CALIFORNIA COASTAL COMMISSION

**STAFF REPORT: APPEAL
SUBSTANTIAL ISSUE DETERMINATION
AND DE NOVO REVIEW**

Appeal Number..... A-3-SLO-00-121
Local Government..... San Luis Obispo County
Decision Approved with Conditions
Applicant Tom & Karen Hogan
Appellants Ruel J. Czach
Project Location 36 North Ocean Avenue (Estero Planning Area), Cayucos, San Luis Obispo County (APN 064-114-008)
Project Description..... Allow continued use of approximately 6,400 square feet of outdoor building material storage area in association with an existing hardware store; replacement of fence and installation of retaining wall.
File Documents San Luis Obispo County certified Local Coastal Program; Local Administrative Record for Coastal Development Permit D990094D; *Riparian Vegetation of Little Cayucos Creek Next to Ocean Avenue Hardware* (V.L. Holland, Ph.D., June 9, 2000).

SITE PHOTOS

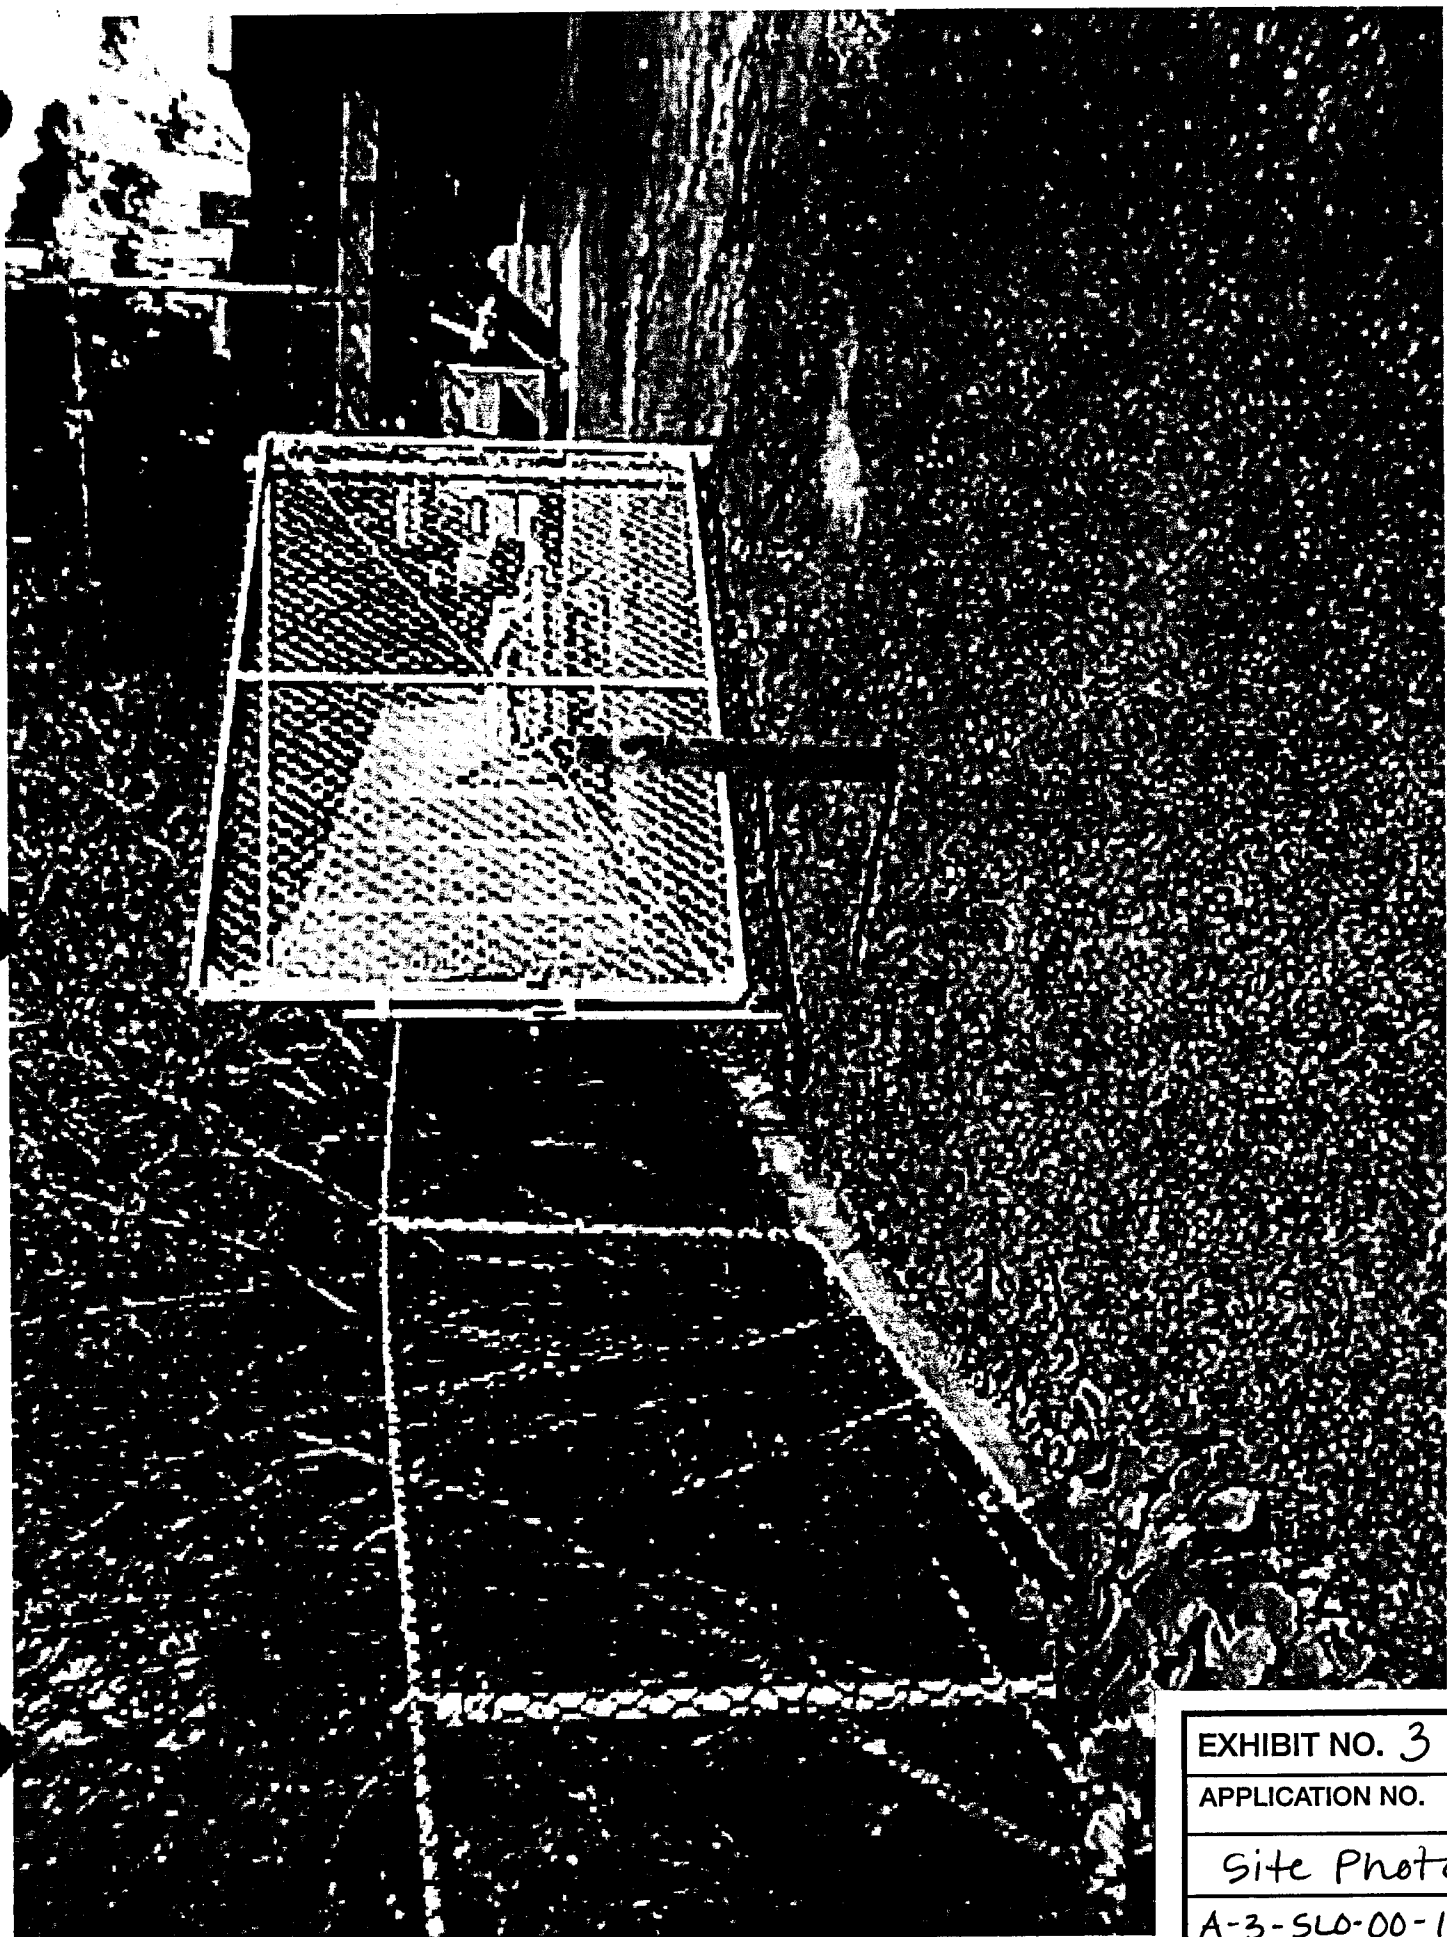
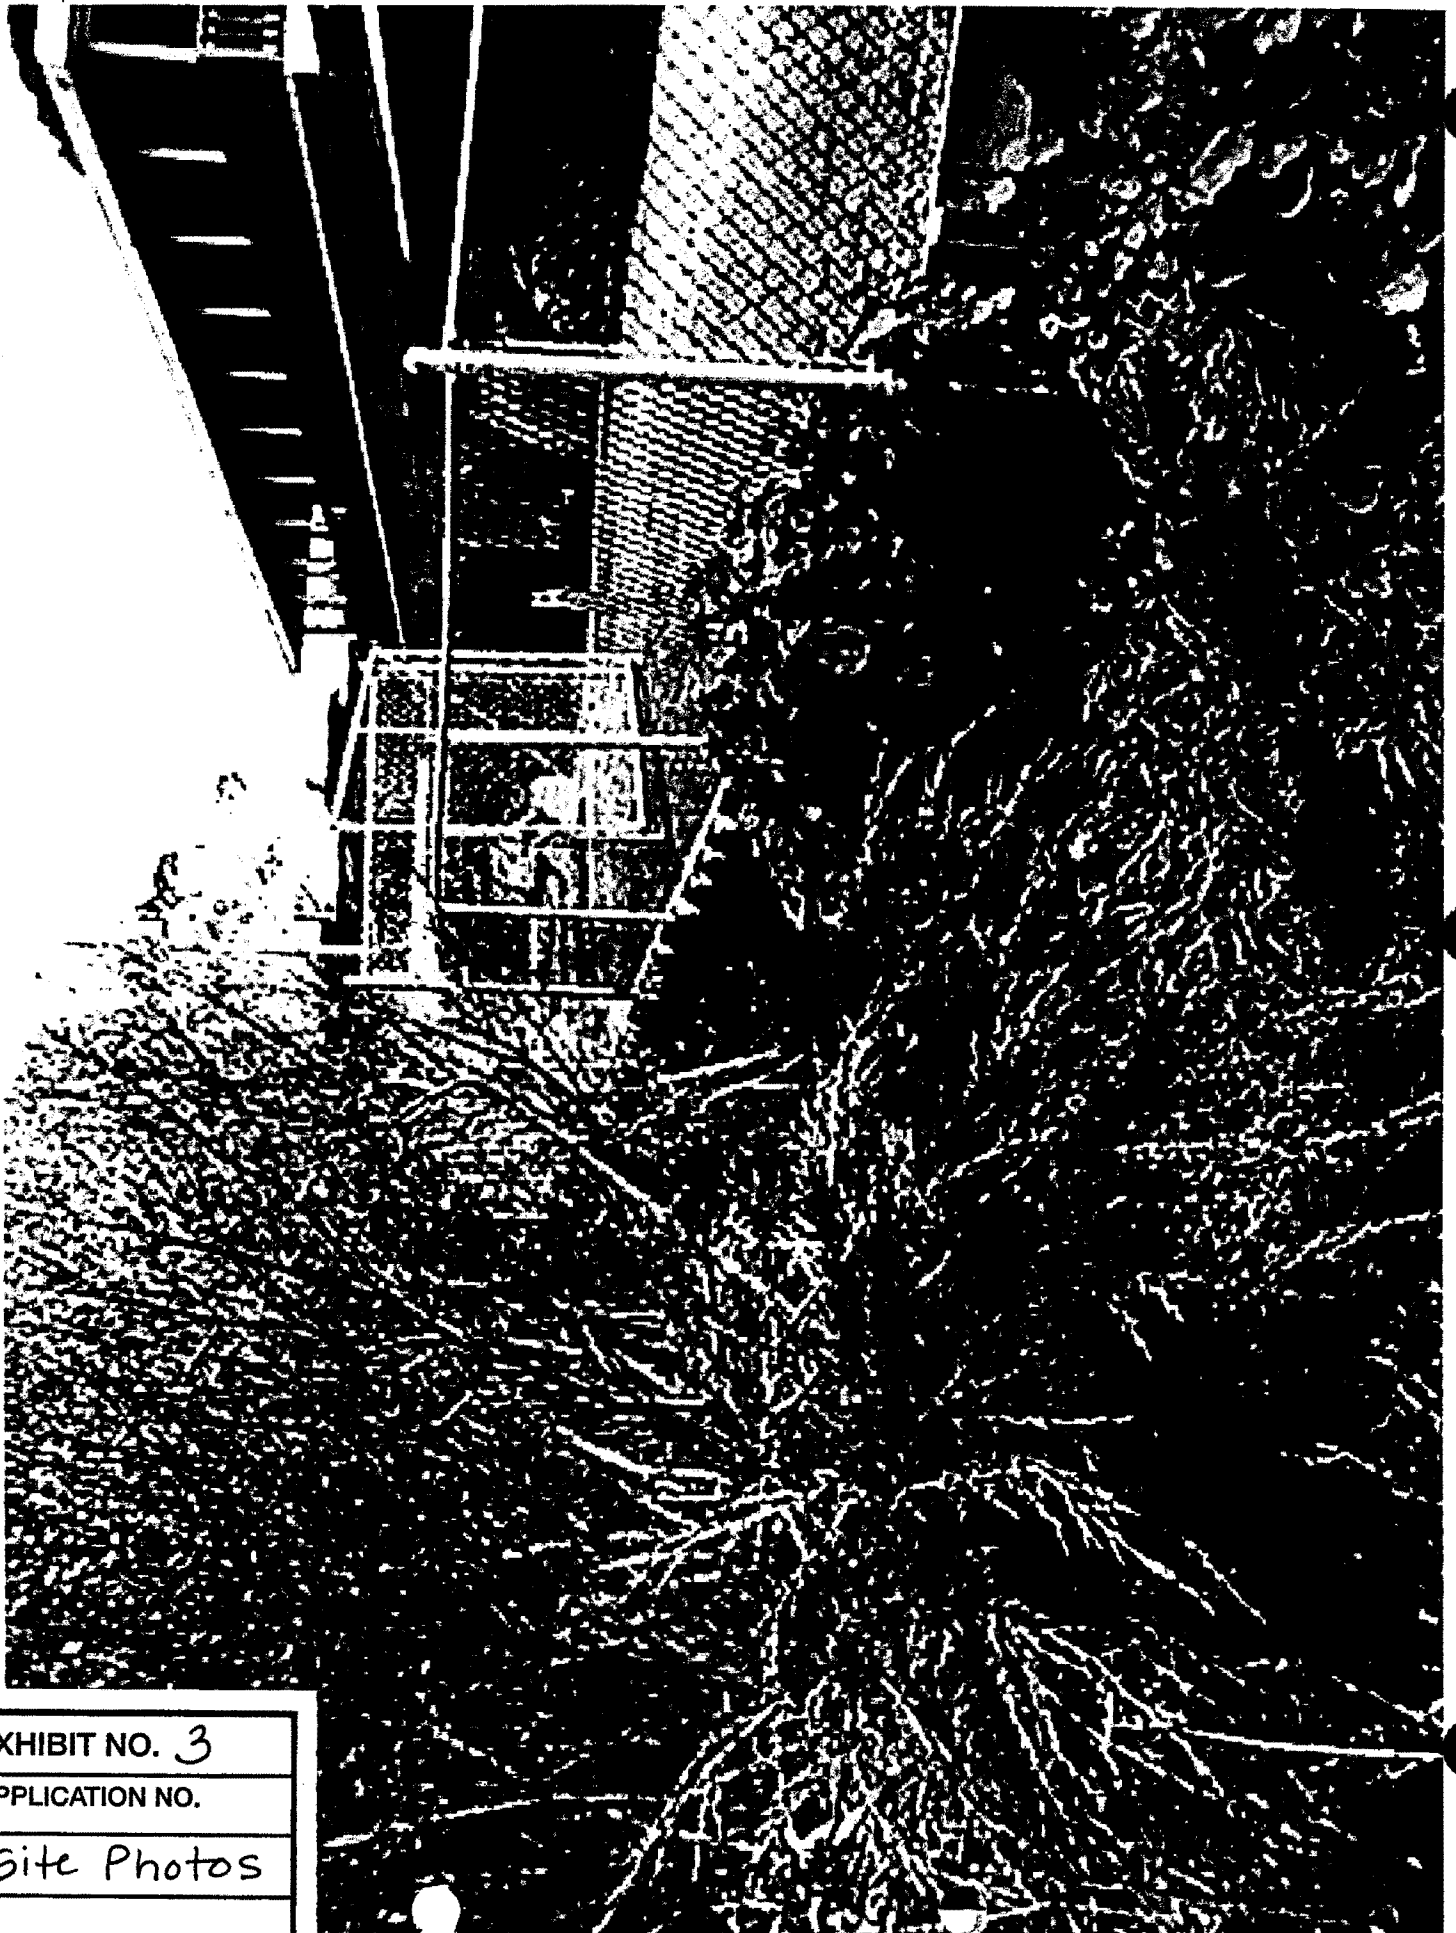
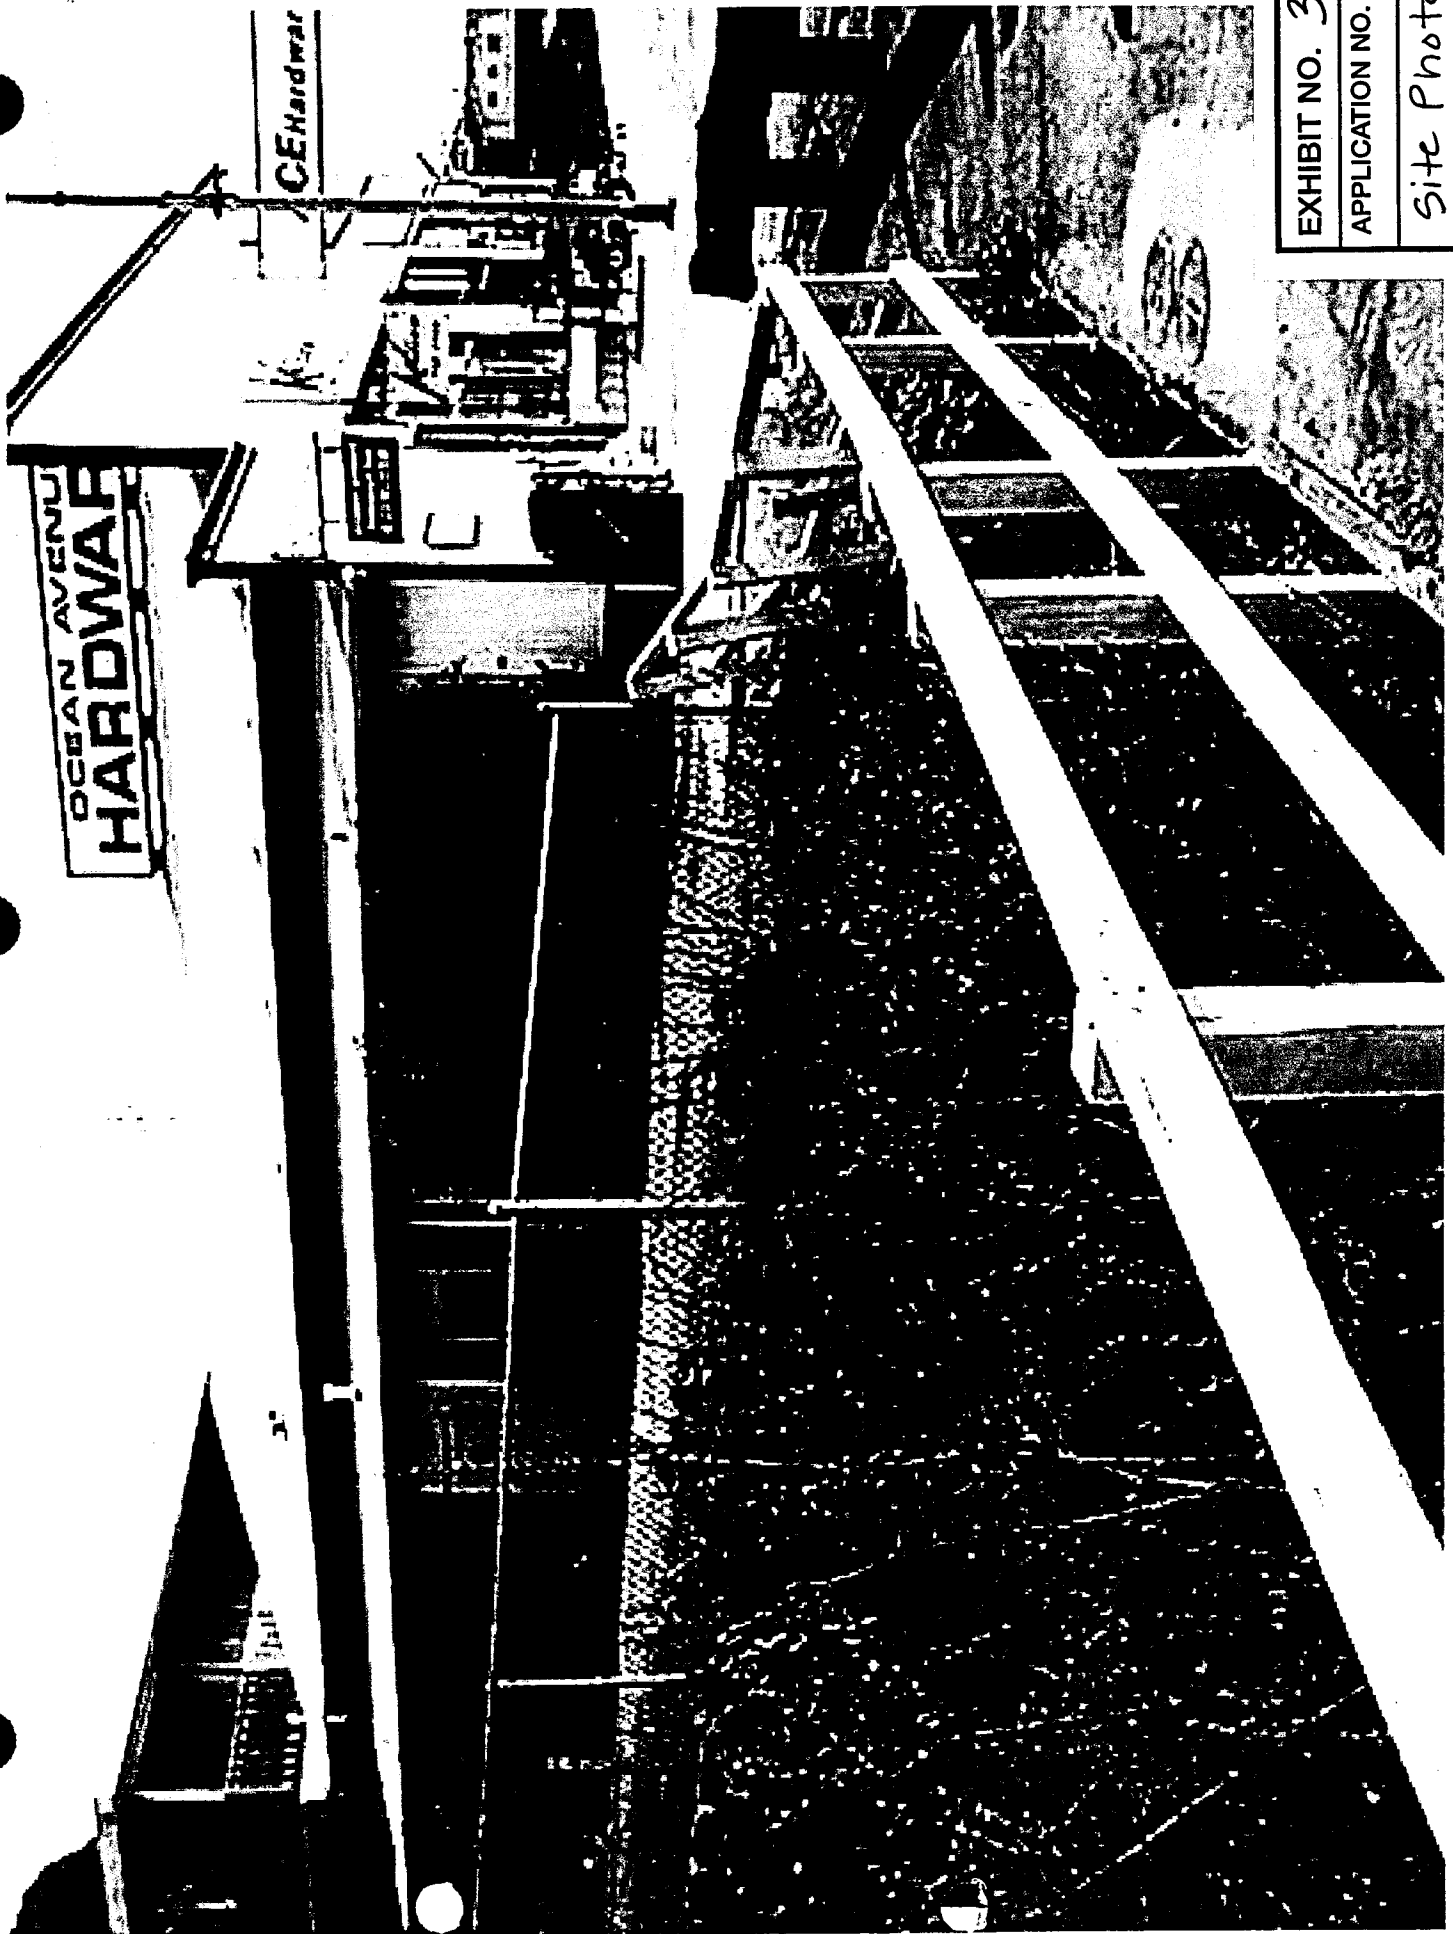
the top of the creek bank. The property on the north side of the creek contains the Way Station Building, which is located right on the top of the creek bank (see Exhibit 3).
